This responds to the Defense Nuclear Facilities Safety Board's (Board) May 17, 2018, letter regarding the structural integrity of the H-Canyon Exhaust Tunnel (CAEX) at the Savannah River Site (SRS).

Enclosure for Continued Structural Integrity of the H-Canyon Exhaust Tunnel

Response to DNFSB Letter of May 17, 2018

Figure 1. ANSYS Single Tunnel Model

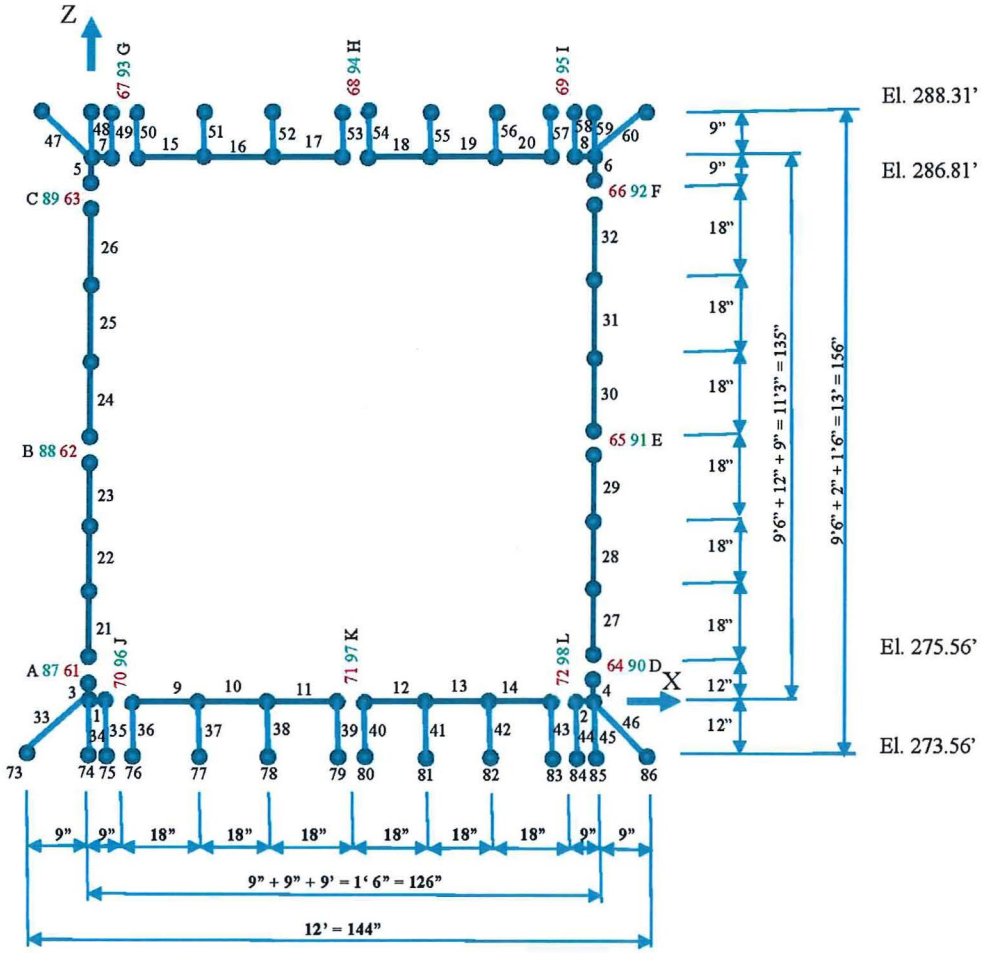
A schematic of the model is shown in Figure 1. The model consists of rigid beam elements at the wall/slab joints, non-linear rotational springs at the top, bottom, and middle of each wall or slab, and beam elements (that represent the walls and slabs) connecting the non-linear rotational springs. Since the interior reinforcing bars are considered exposed and ineffective, there is essentially zero moment capacity for tension on the inside face of the tunnel. Under certain load conditions, a mechanism could form in the model allowing nearly free rigid body rotation of sections of the tunnel. The vertical and lateral soil loads have opposite effects on the tunnel – vertical soil loads cause downward deflection of the roof and outward deflection of the walls while lateral soil loads on the walls cause deflections in the opposite direction. Consequently, the model is expected to be stable under the combined vertical and lateral soil loading. Application of increasing levels of lateral racking displacements are expected to eventually cause the formation of a mechanism indicated by a significant reduction in load capacity or non-convergence of the solution.

Preliminary backbone curve results indicate the structure (with conservative material properties) remains stable up to a lateral displacement of approximately 0.6 inches. This lateral displacement capacity was achieved for both 0 inches and 2 inches of additional concrete degradation. However, as expected, less force is required to achieve the same displacement in the more degraded model. While this is not a very large lateral displacement capacity overall, it is still several times larger than the preliminary DBE displacements from SHAKE (see discussion for Item #6 above). This is true, even considering the soil displacements discussed in Item #6 above, and will need to be factored to account for the relative stiffness between the soil and tunnel structure as recommended by Wang [13]. Preliminary results indicate a higher displacement capacity for median material properties, as expected, given the results from conservative material properties.

Figure 2. ANSYS Double Tunnel Model

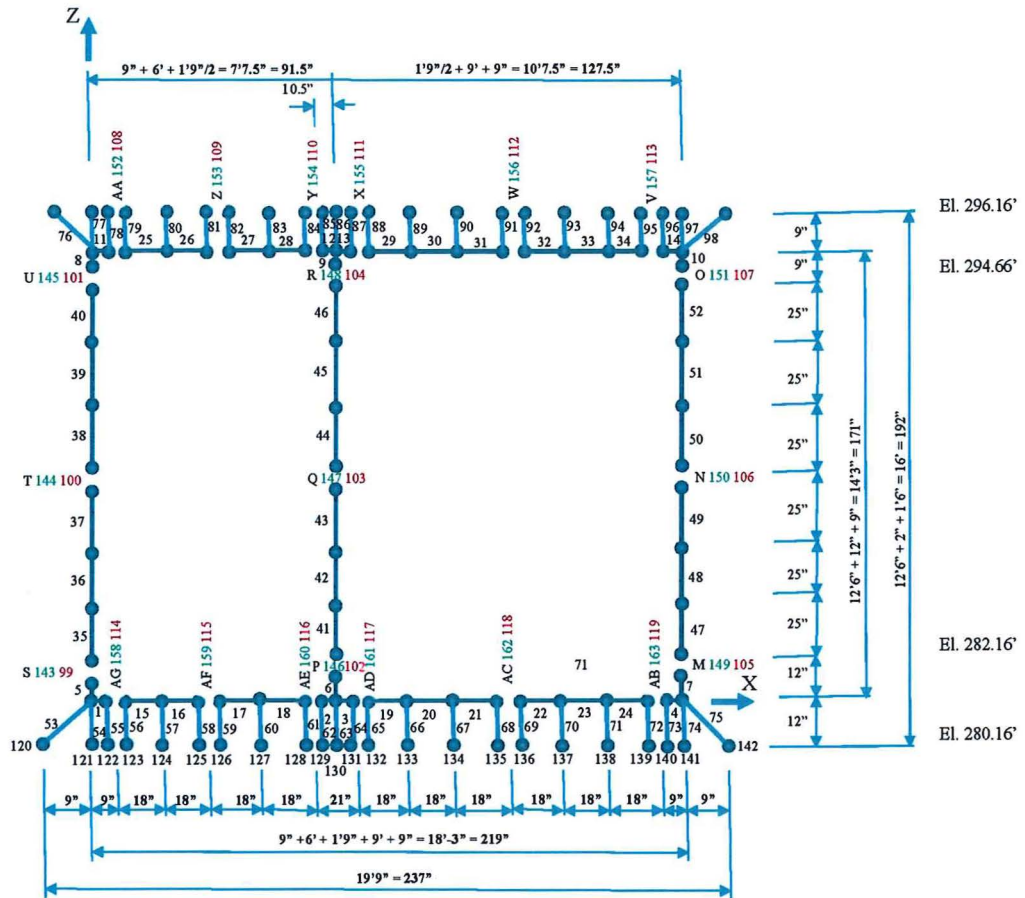
Since the Center Section Exhaust Tunnel does not contact process air, it is assumed to not be degraded in the model, the double tunnel model is inherently more stable than the single tunnel model and has less lateral displacement compared to the single tunnel for the same lateral load. A schematic of the model is shown in Figure 2.
